Technical Service Bulletin

SUBJECT:		No:	TSB-20-42A-001
CORRECTION TO TIGHTENING TORQUE OF TAILGATE LATCH BOLT - SMR		DATE:	February 2020
		MODEL:	2019-20 Outlander Sport/RVR
CIRCULATE TO:	<input type="checkbox"/> GENERAL MANAGER	<input checked="" type="checkbox"/> PARTS MANAGER	<input checked="" type="checkbox"/> TECHNICIAN
<input checked="" type="checkbox"/> SERVICE ADVISOR	<input checked="" type="checkbox"/> SERVICE MANAGER	<input type="checkbox"/> WARRANTY PROCESSOR	<input type="checkbox"/> SALES MANAGER

**LIFTGATE HANDLE AND LATCH
 REMOVAL AND INSTALLATION**

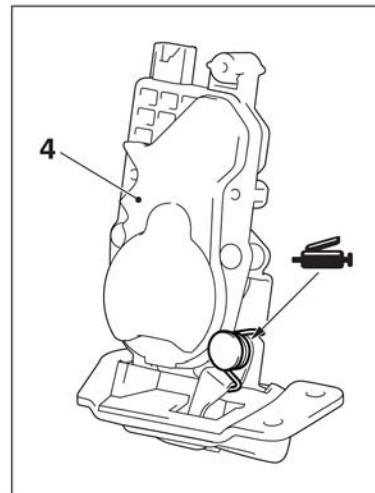
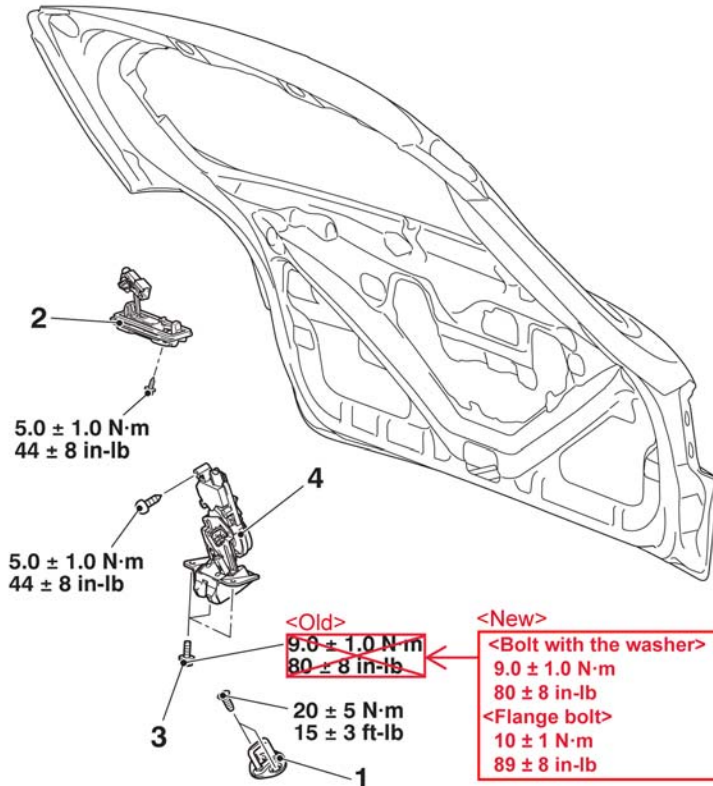
Please make the indicated changes to the 2019 Outlander Sport/RVR Service Manual, Group 42A-Body -> Liftgate -> Liftgate Handle and Latch -> Removal and Installation.

NOTE: For 2019 MY vehicles, there are 2 types of bolts depending on production date.

- **Production to end of April 2019: Bolt with washer**
- **Production from May 2019: Flange Bolt**

This TSB updates the Body section of the affected Service Manuals to correct the tightening torque of the fixing bolt for the tailgate latch, and to distinguish the different torques for the 2 types of bolts for 2019 model year vehicles.

**LIFTGATE HANDLE AND LATCH
 REMOVAL AND INSTALLATION**

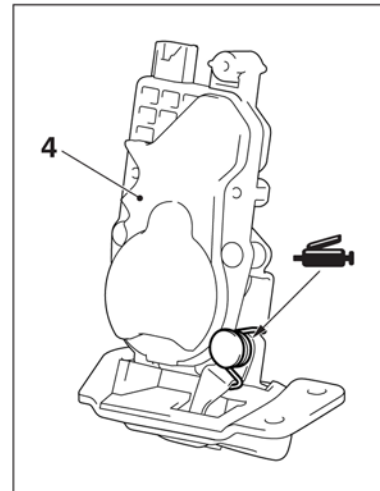
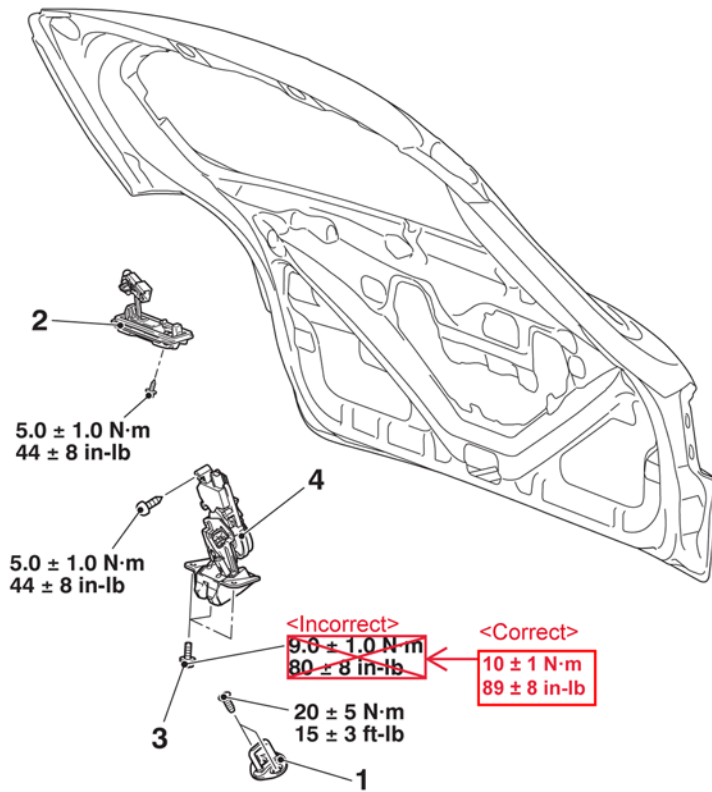
Please make the indicated changes to the 2020 Outlander Sport/RVR Service Manual, Group 42A-Body -> Liftgate -> Liftgate Handle and Latch -> Removal and Installation.
